HILLIARD PLANNING AND ZONING BOARD MEETING

TUESDAY, FEBRUARY 13, 2024, 7:00 PM

SUBJECT: Planning and Zoning Board approval of the Site Plan Application No. 20221025.
Parcel ID No. 17-3N-24-2020-0057-0000. Address 3714 Raven Drive.
Property Owner- Gregg Simmons

HILLIARD RV	
EXISTING CONDITIONS	
Date:	06/2022
Designer:	HAV
Job #:	21-071
Drawn:	MRP
Scale:	1:60
Sheet:	3

Date:	06/2022
Designer:	HAV
Job #:	21-071
Drawn:	MRP
Scale:	1:30
Sheet:	9.02

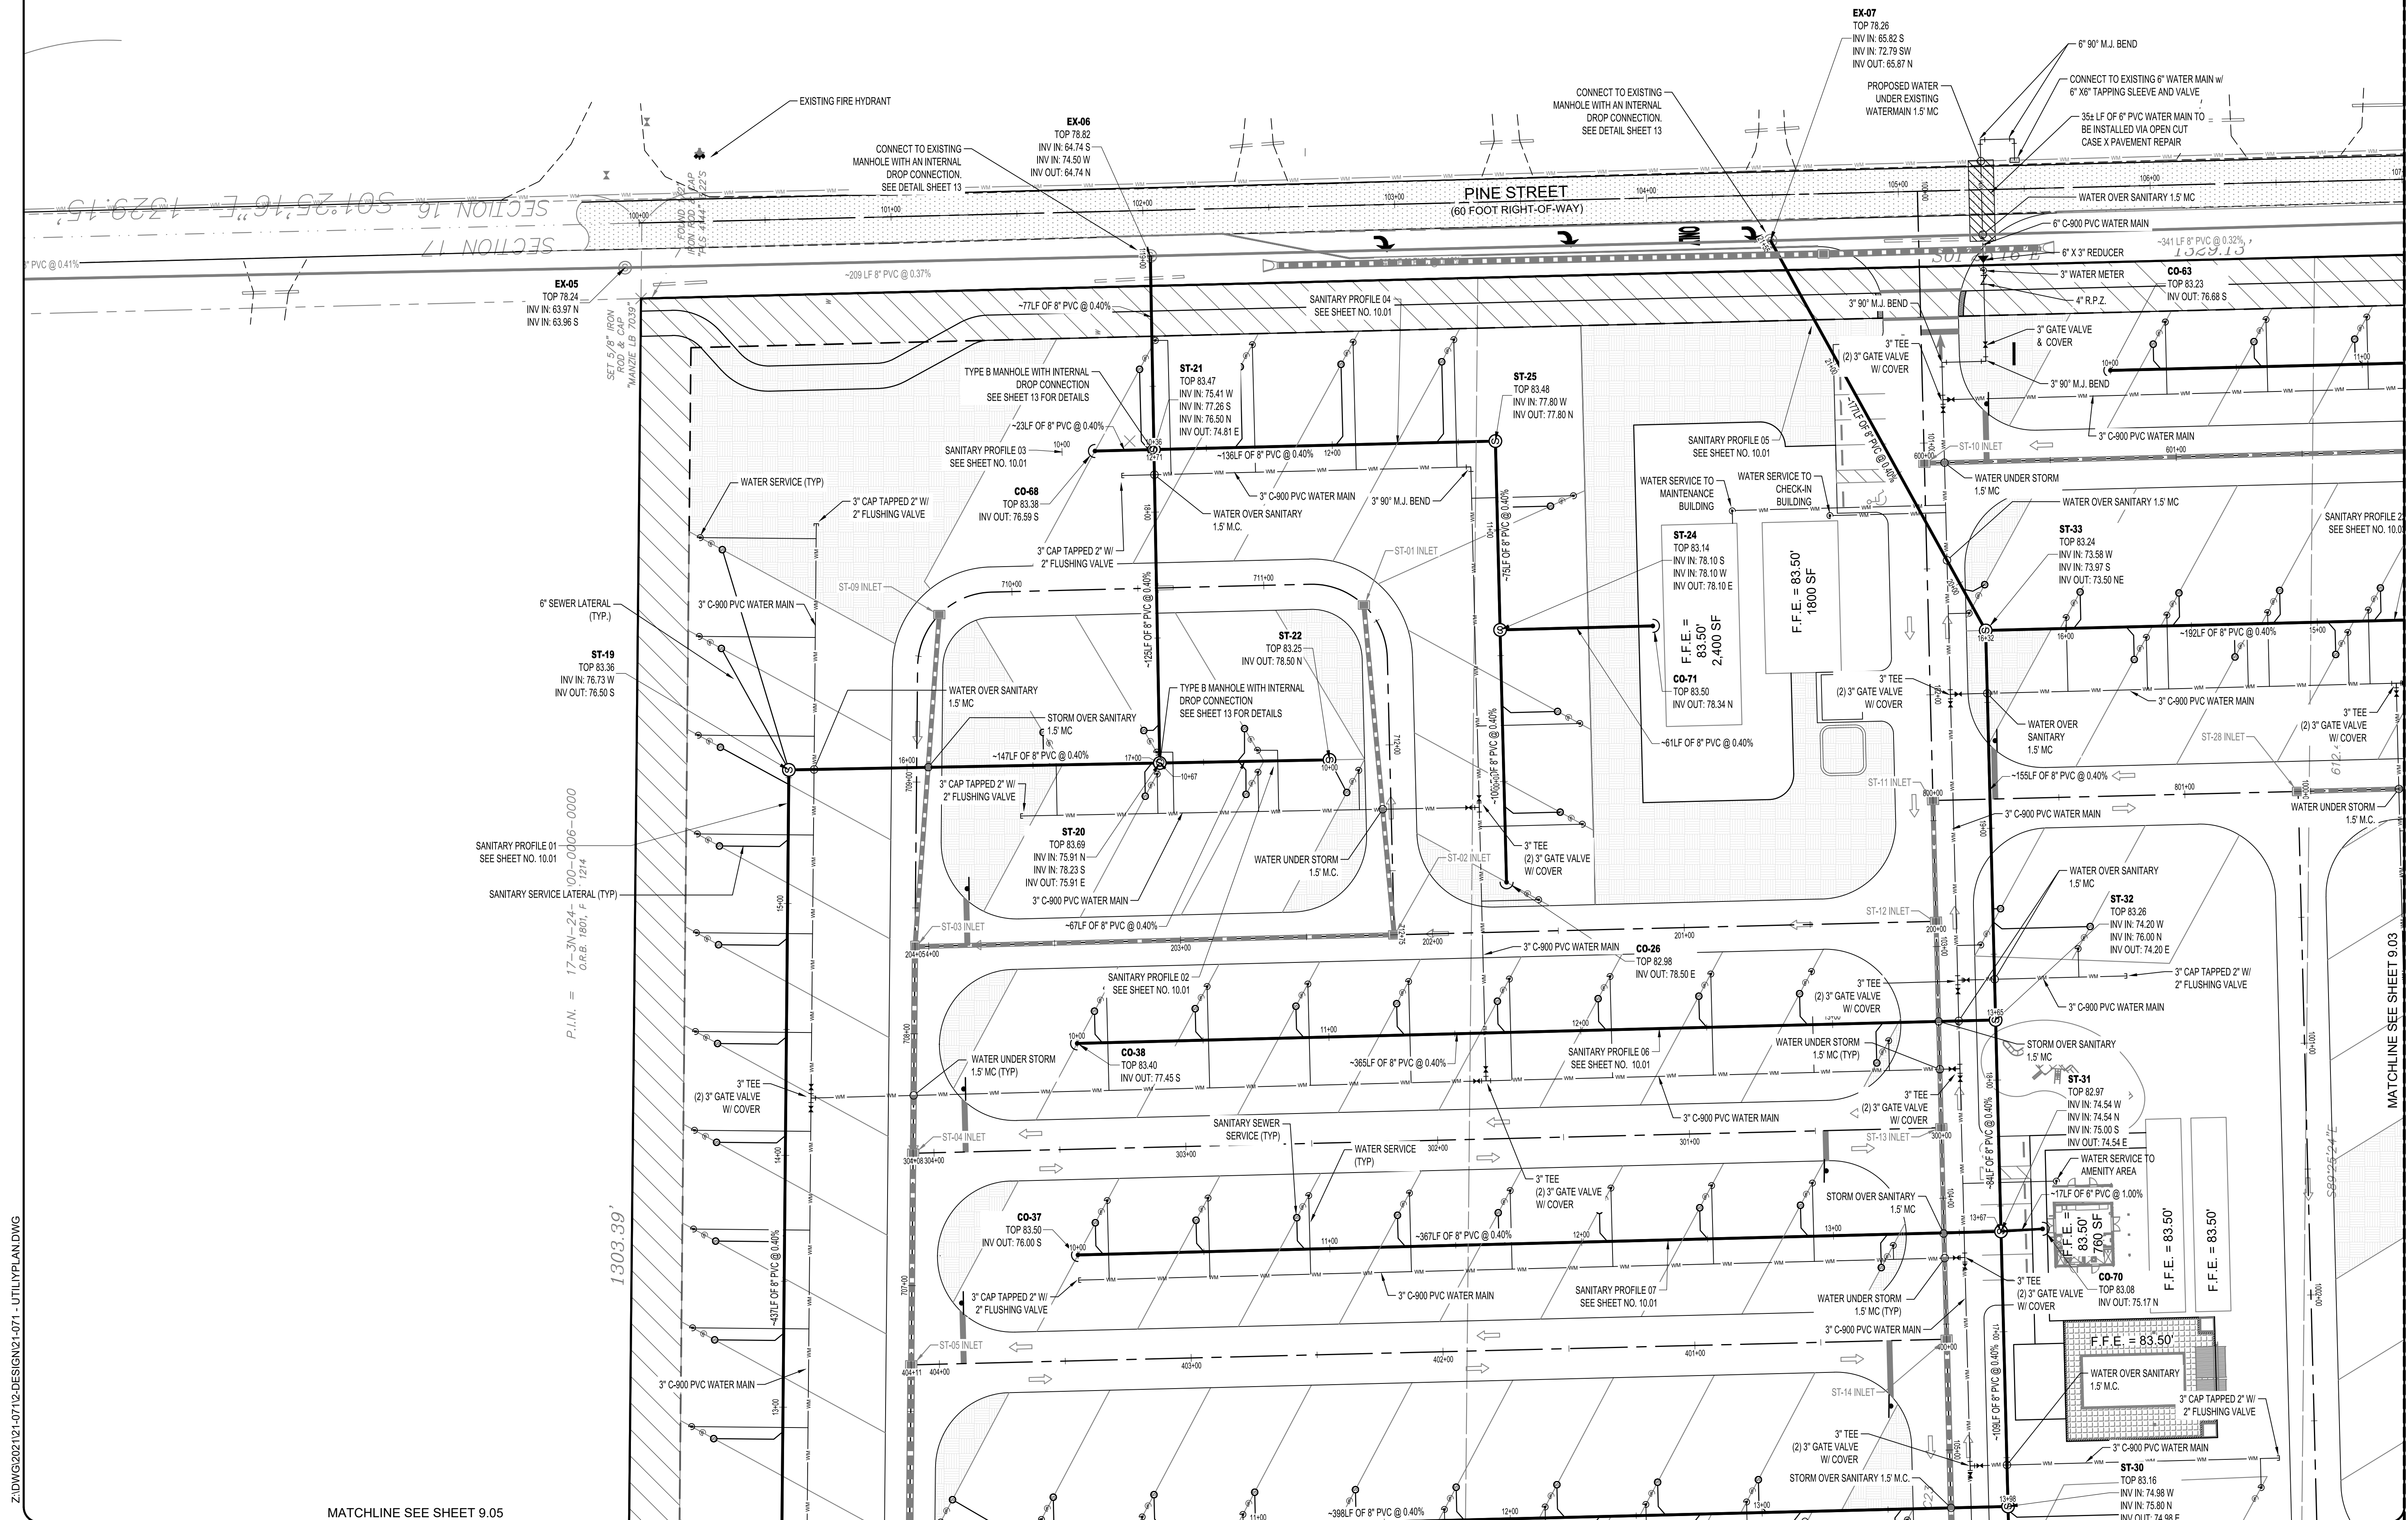
1. Correct southern Matchline on Sheet 9.02 to match with Sheet 9.03, not 9.02.
